THE MARYLAND ZOO IN BALTIMORE

PERIMETER GATE REPORT

SEPTEMBER 2021

#24 BLACKSMITH GATE

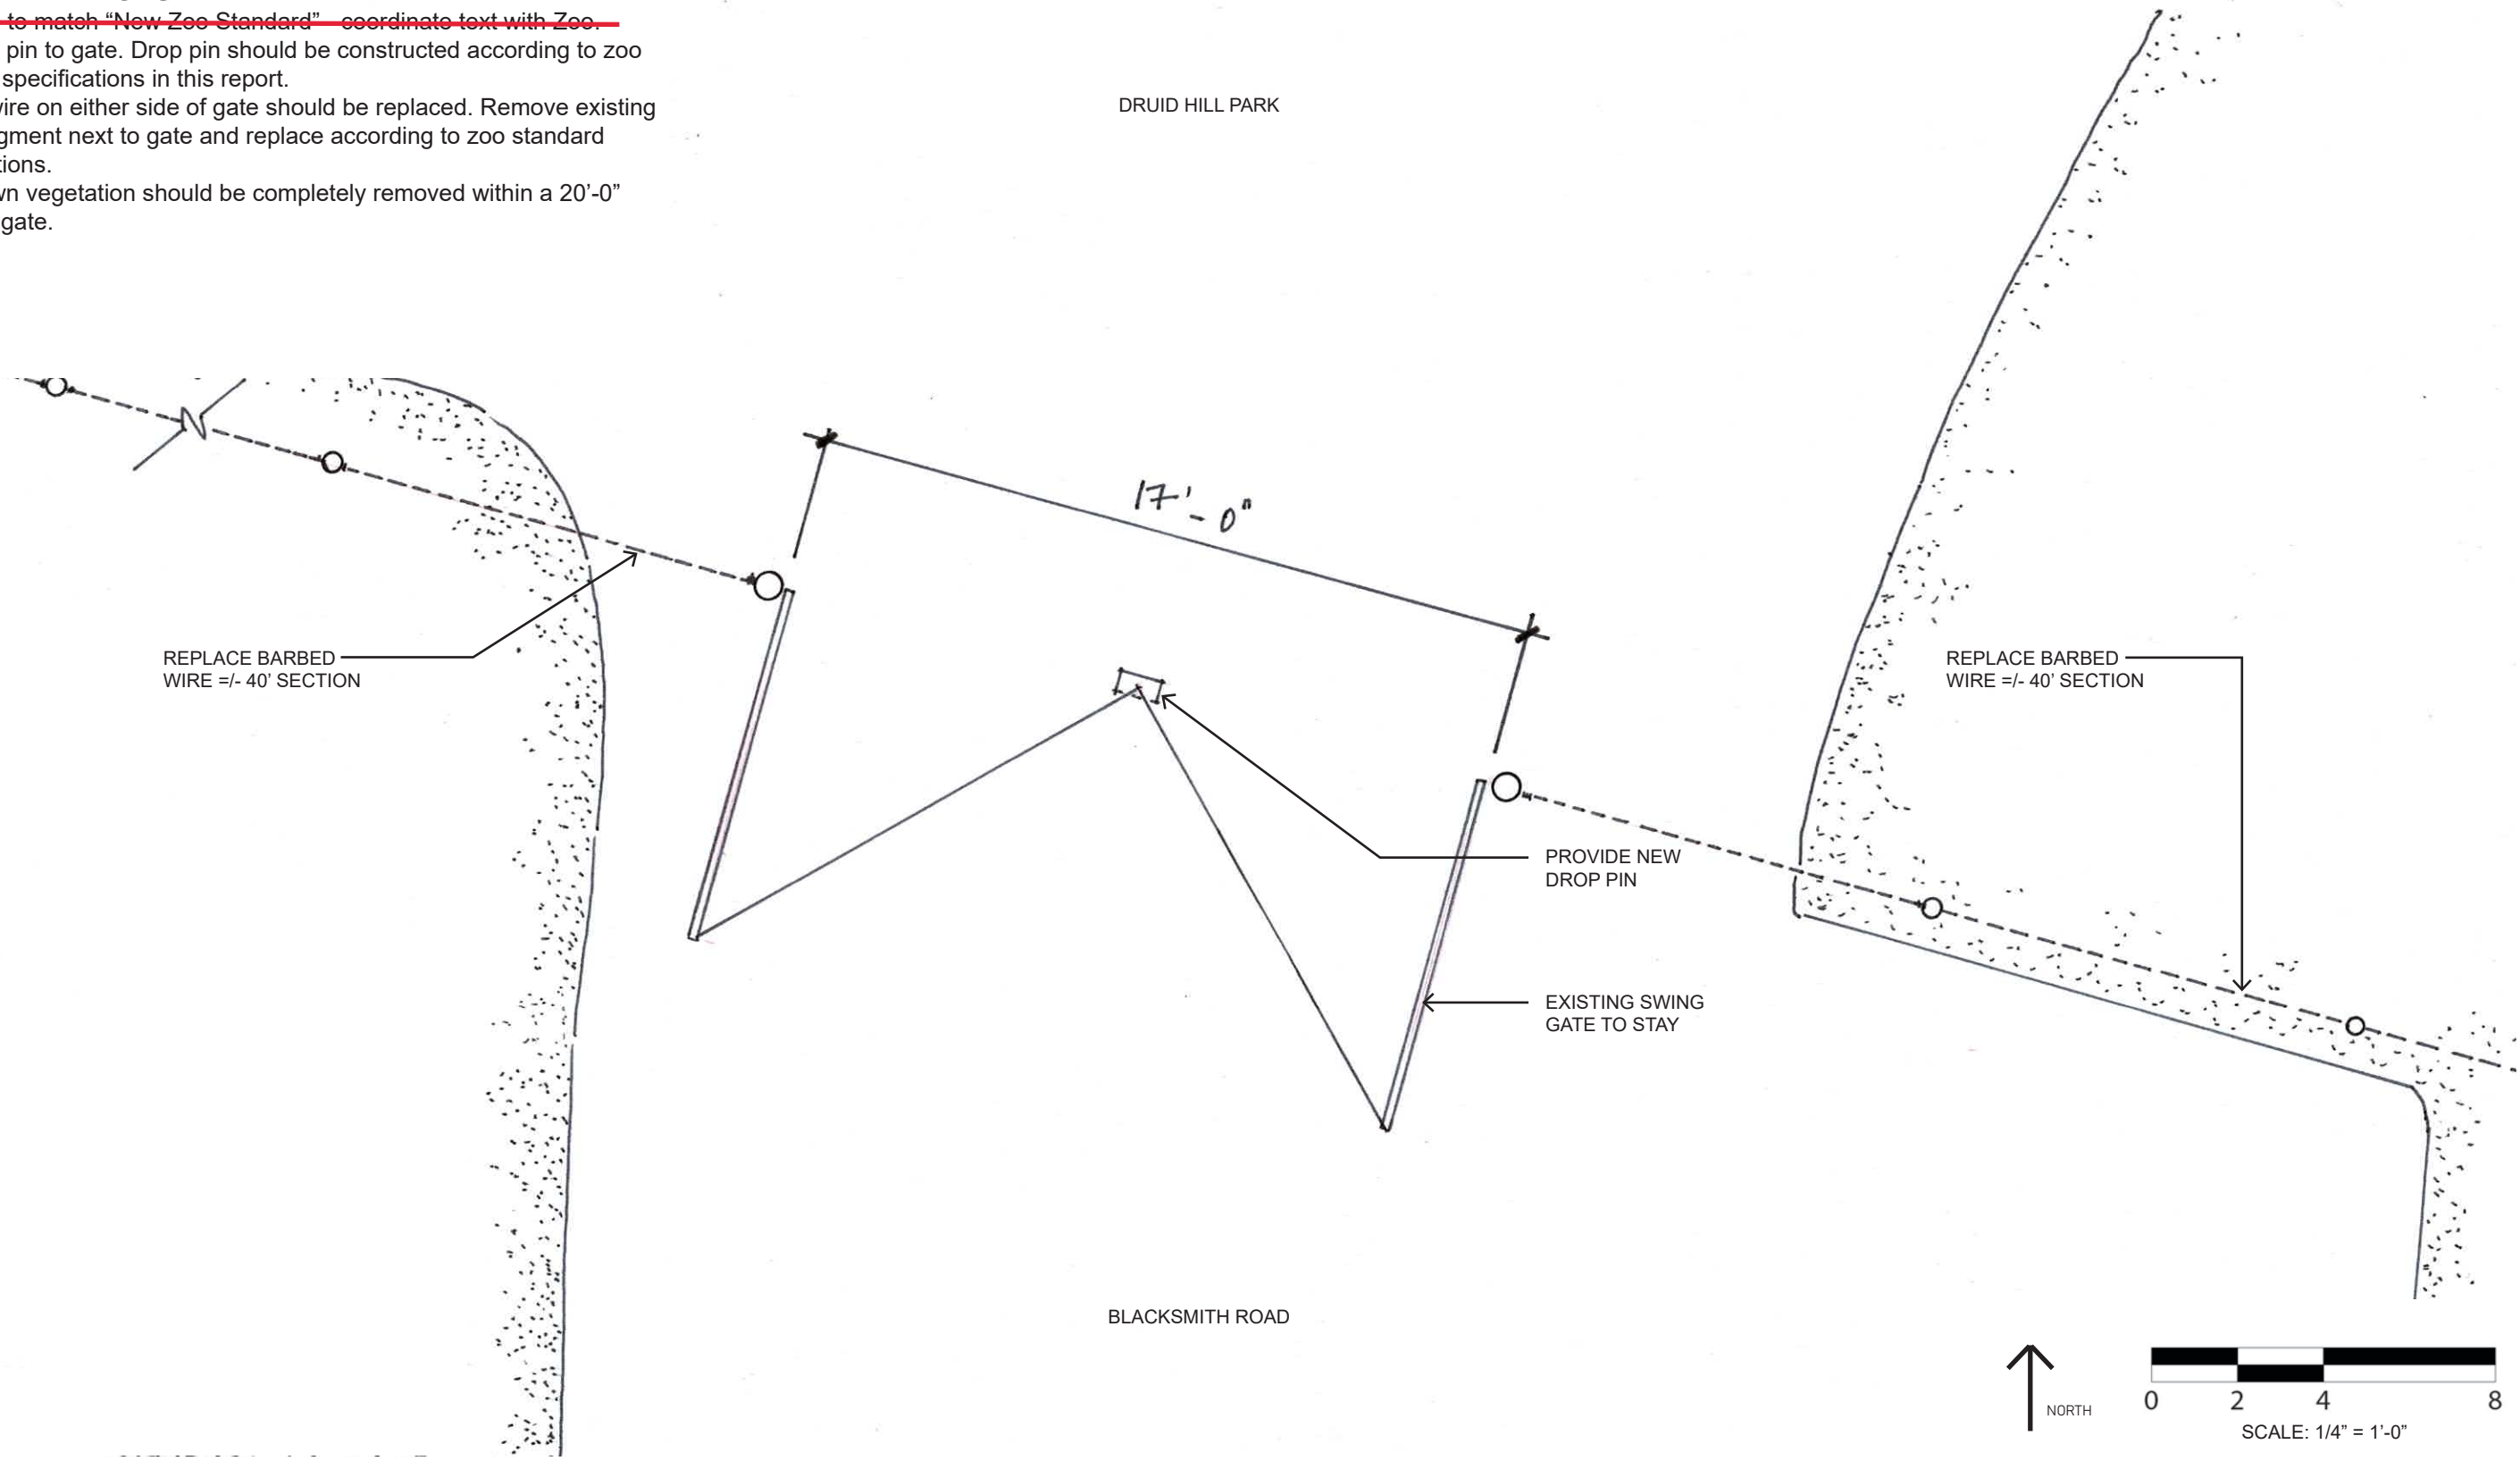
- ~~New sign to match "New Zoo Standard" coordinate text with Zoo.~~
- Add drop pin to gate. Drop pin should be constructed according to zoo standard specifications in this report.
- Barbed wire on either side of gate should be replaced. Remove existing 40'-0" segment next to gate and replace according to zoo standard specifications.
- Overgrown vegetation should be completely removed within a 20'-0" radius of gate.

#25 GIRAFFE/CLIPPER ESPLANADE GATE

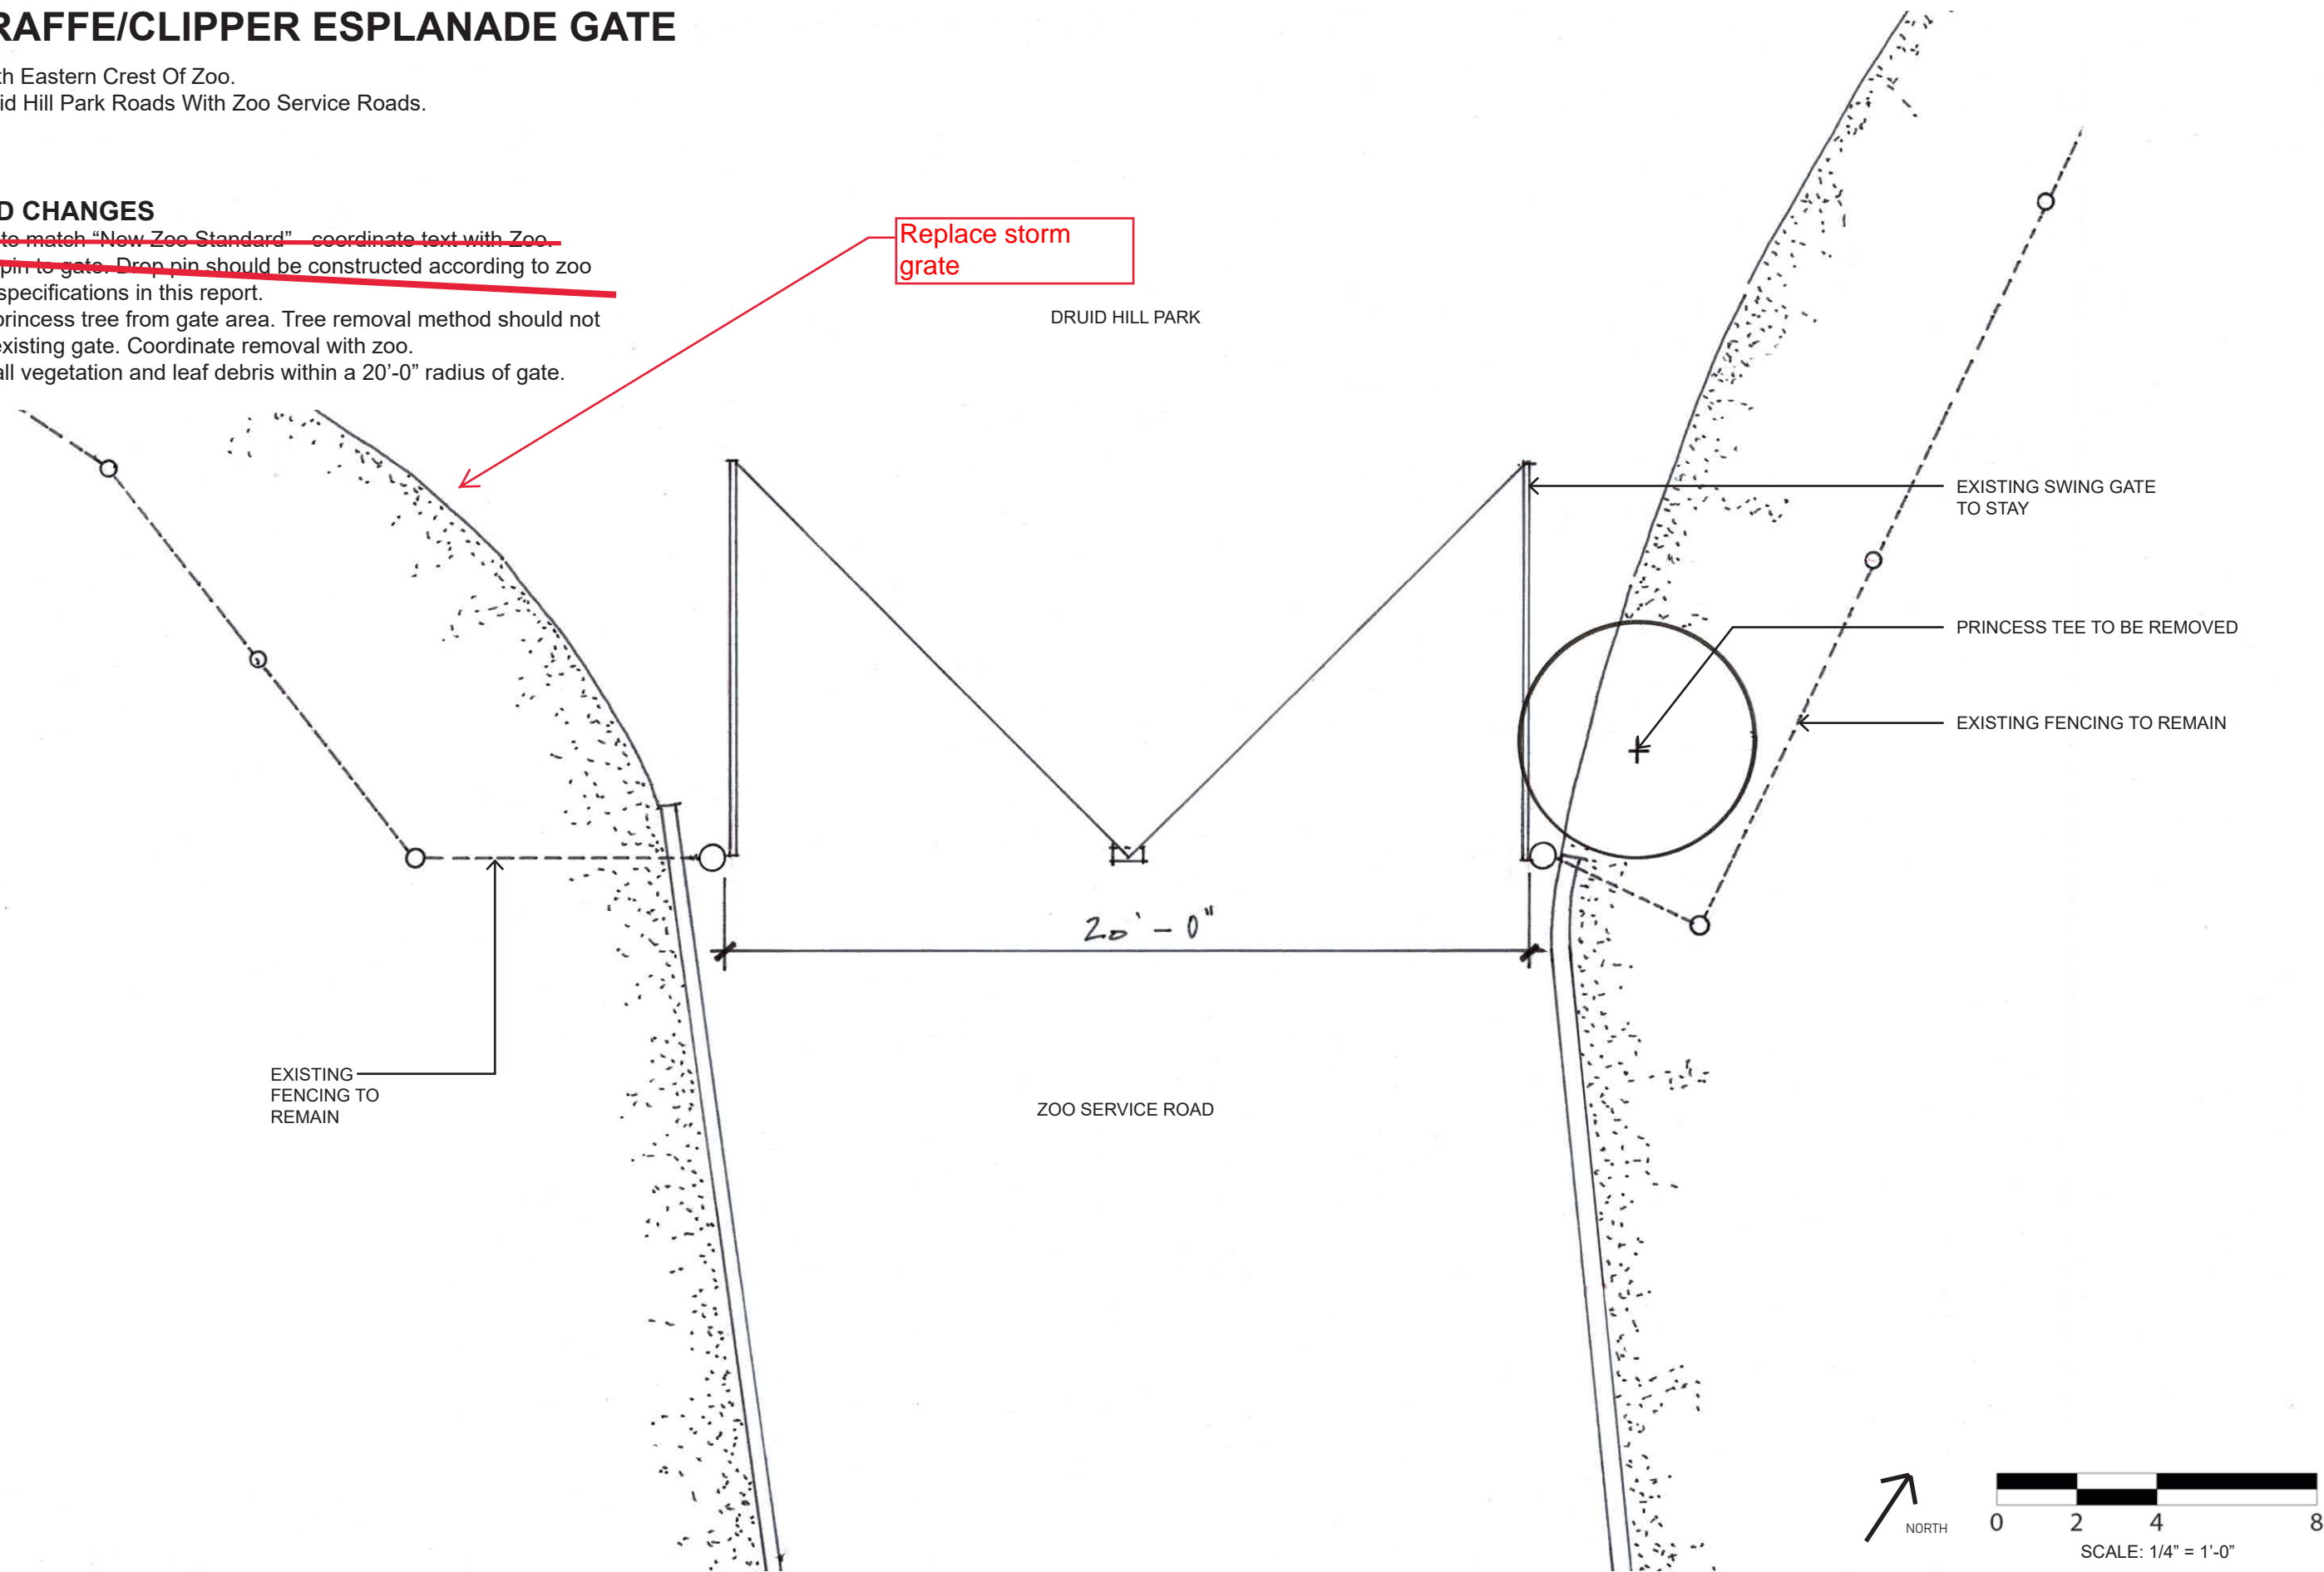
- ~~New sign to match "New Zoo Standard" coordinate text with Zoo.~~
- ~~Add drop pin to gate. Drop pin should be constructed according to zoo standard specifications in this report.~~
- Remove princess tree from gate area. Tree removal method should not damage existing gate. Coordinate removal with zoo.
- Remove all vegetation and leaf debris within a 20'-0" radius of gate.

#26 SIBERIAN/TRAIN STATION VEHICLE GATE

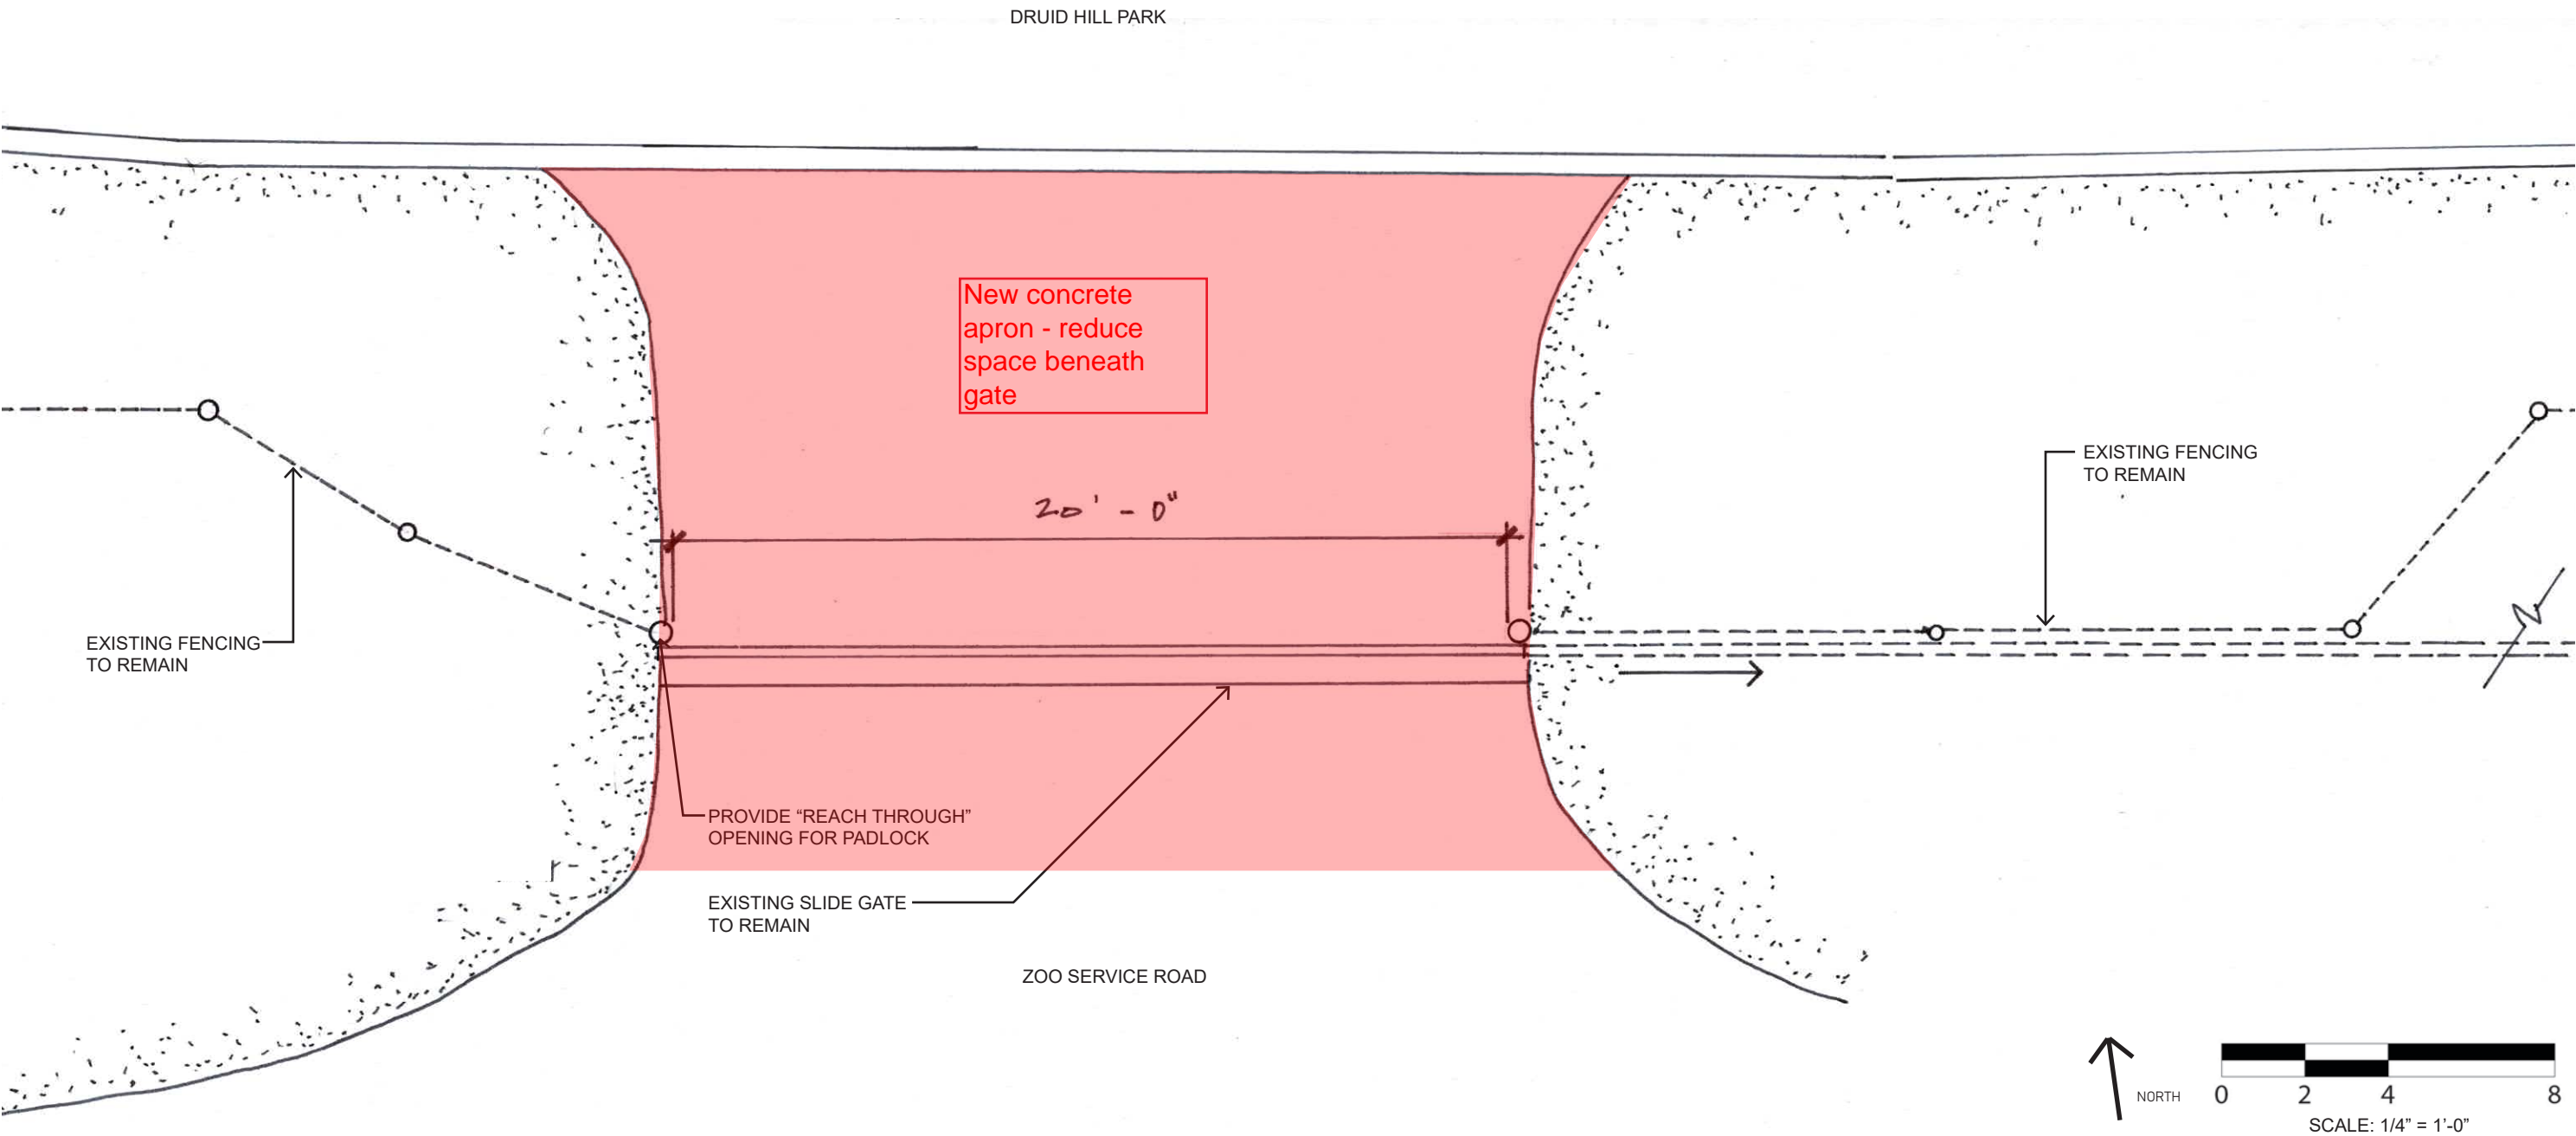
- ~~New sign to match "New Zoo Standard" coordinate text with Zoo.~~
- Add new locking mechanism to gate. Provide "reach through padlock" and coordinate product and placement with zoo.
- ~~Add gate skirt.~~
